BELL BEND NUCLEAR POWER PLANT
RESPONSE TO RAI No. 37 AND
SCHEDULE INFORMATION
BNP-2009-244 Docket No. 52-039

References: 1) M. Canova (NRC) to R. Sgarro (PPL Bell Bend, LLC), Bell Bend COLA – Request for Information No. 37 (RAI No. 37) – SEB1 -2659, 2660, 2661, e-mail dated July 27, 2009

Response to NRC Request for Additional Information No. 37
Bell Bend Nuclear Power Plant

FIGURE 1-1

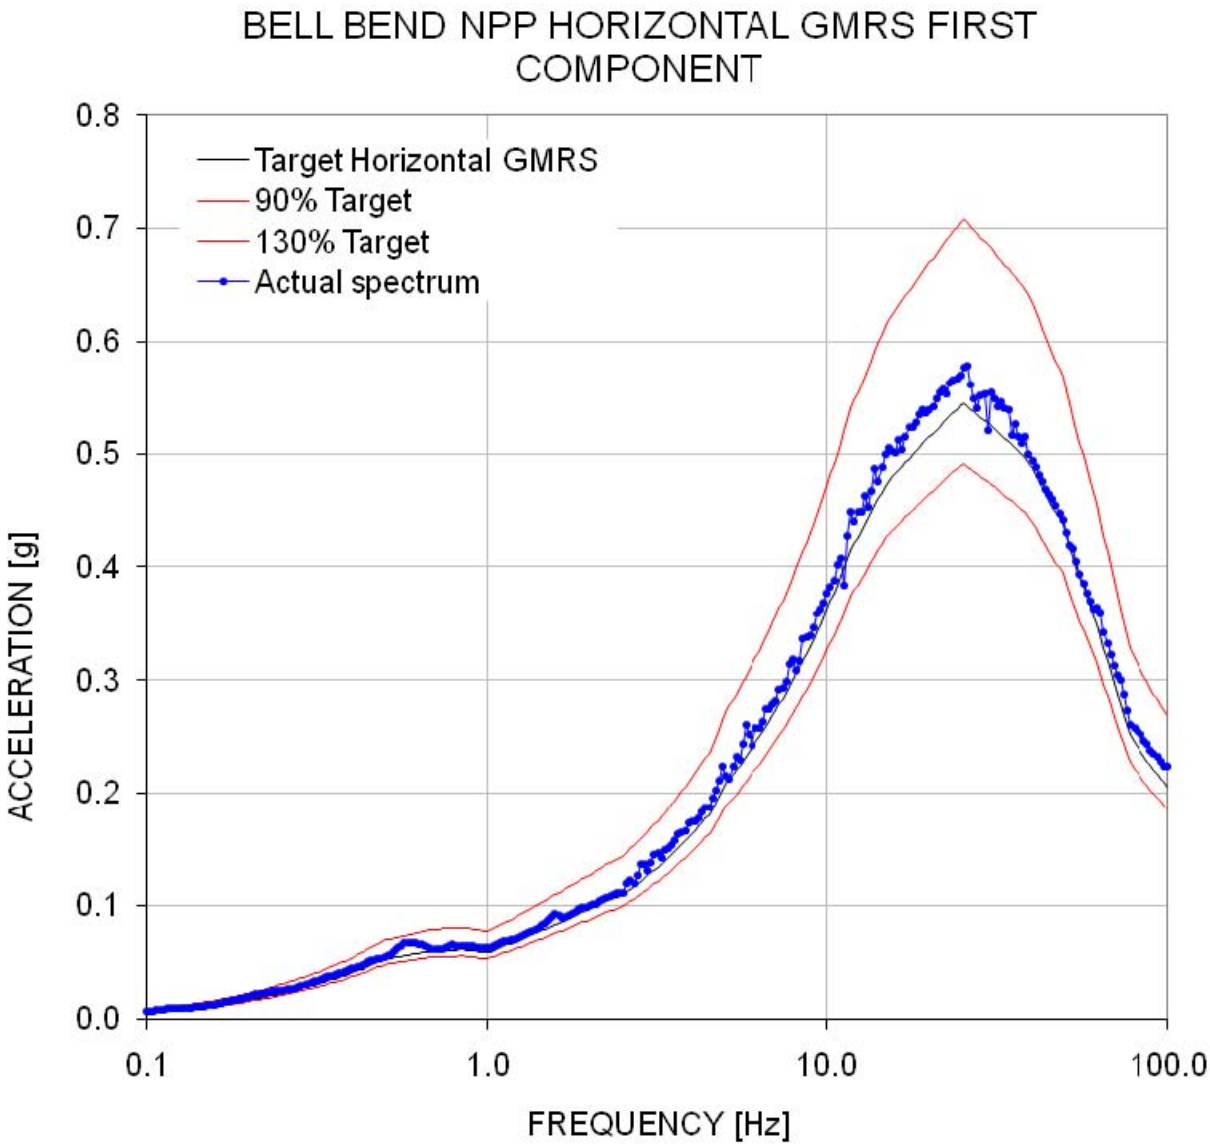
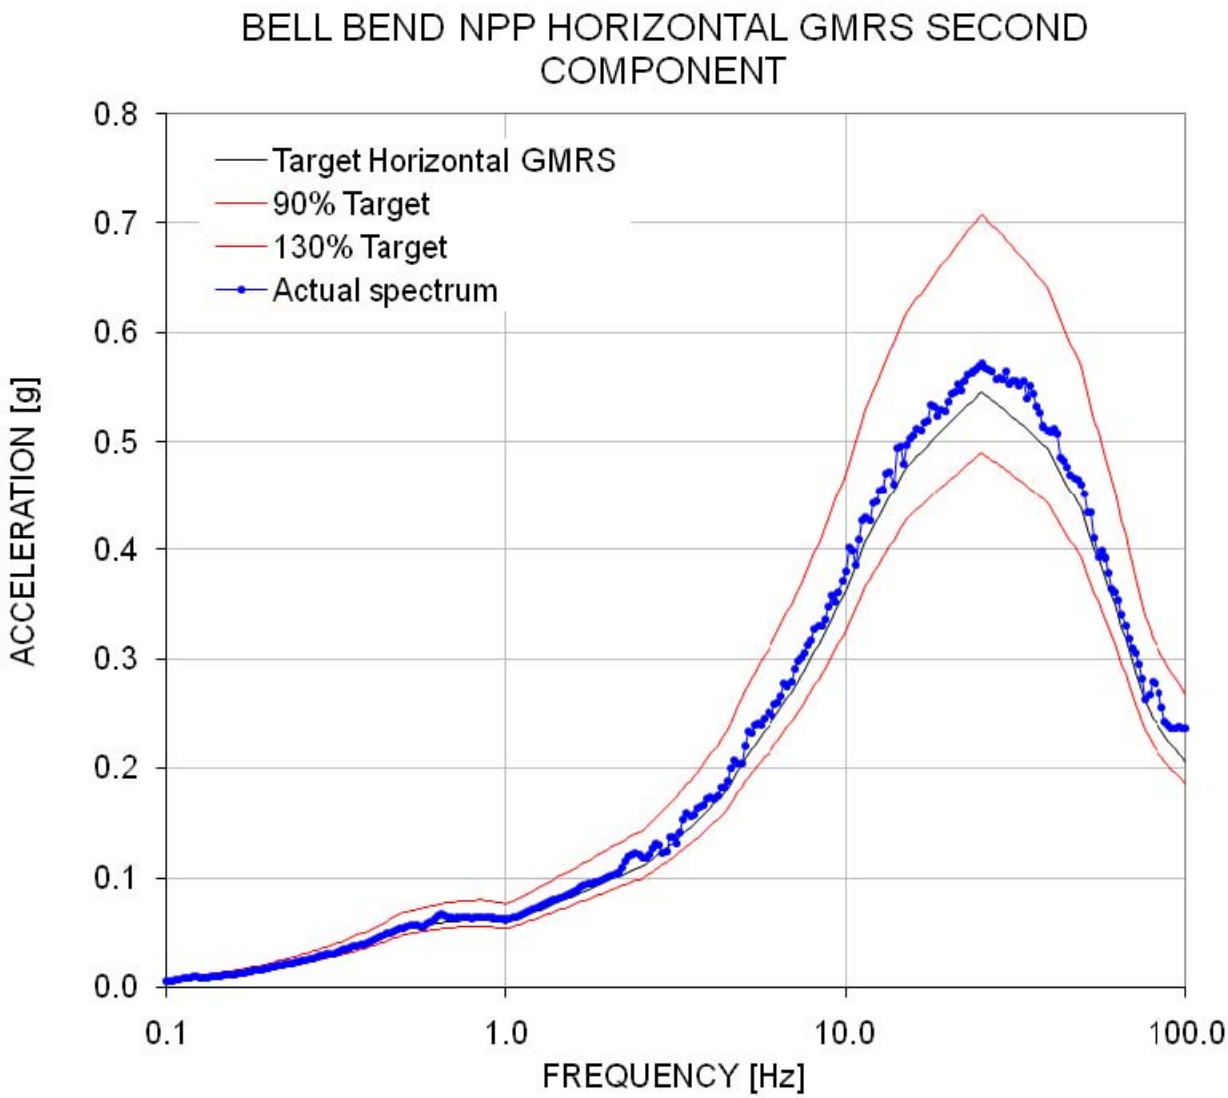
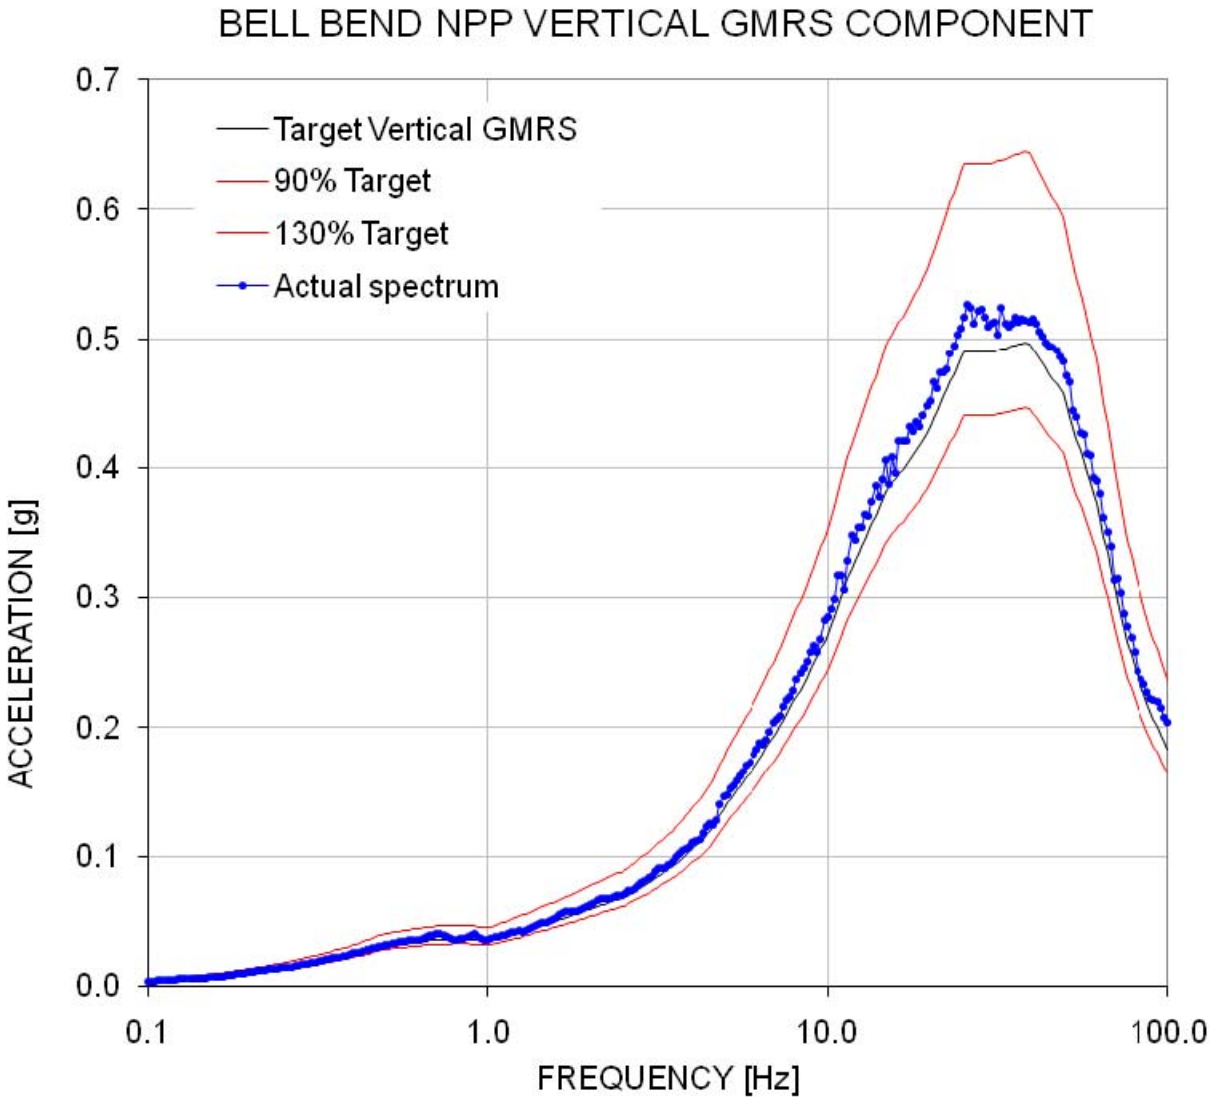
2) A comparison of the response spectra of the input time histories to the GMRS. Demonstrate how the response spectra of the input time histories meet Approach 1 or Approach 2 of NUREG-0800, Standard Review Plan (SRP) Acceptance Criteria 1.B of SRP Section 3.7.1.

Figures 1-1 through 1-3 show the comparison of the 5 percent damped response spectrum of the input time histories, and the 90 percent, 100 percent, and 130 percent target response spectra. This comparison demonstrates that the 5 percent damped response spectra of the time histories does not drop more than 10 percent below the target response spectra, and does not exceed the target response spectra by more than 30 percent which is consistent with NUREG-0800 Acceptance Criteria 1.B..
